UNITED STATES PATENT AND TRADEMARK OFFICE

APPLICATION NO.	FILING DATE	FIRST NAMED INVENTOR	ATTORNEY DOCKET NO.	CONFIRMATION NO.
10/773,165	02/09/2004	Nobuya Nakagawa	248538US	6760

Office Action Summary

60-157914

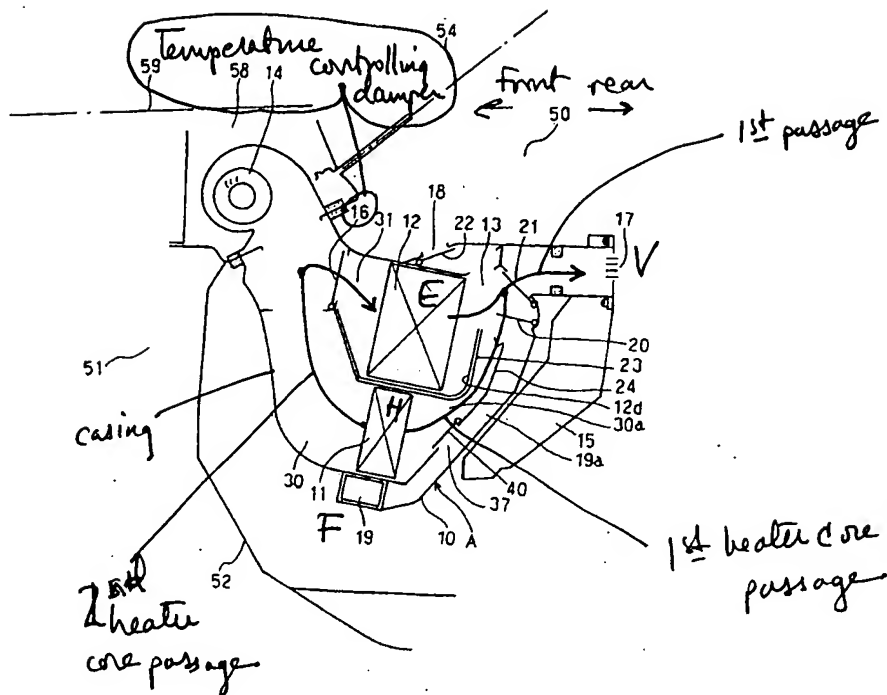
Claims 1 and 2 are rejected under 35 U.S.C. 102(b) as anticipated by or, in the alternative, under 35 U.S.C. 103(a) as obvious over JP 61-188214 or JP 60-157914.

See Figure 1 of JP '214 reproduced below, with the relevant limitations from claims 1 and 2 labeled. A similar Figure is also shown for JP'914.
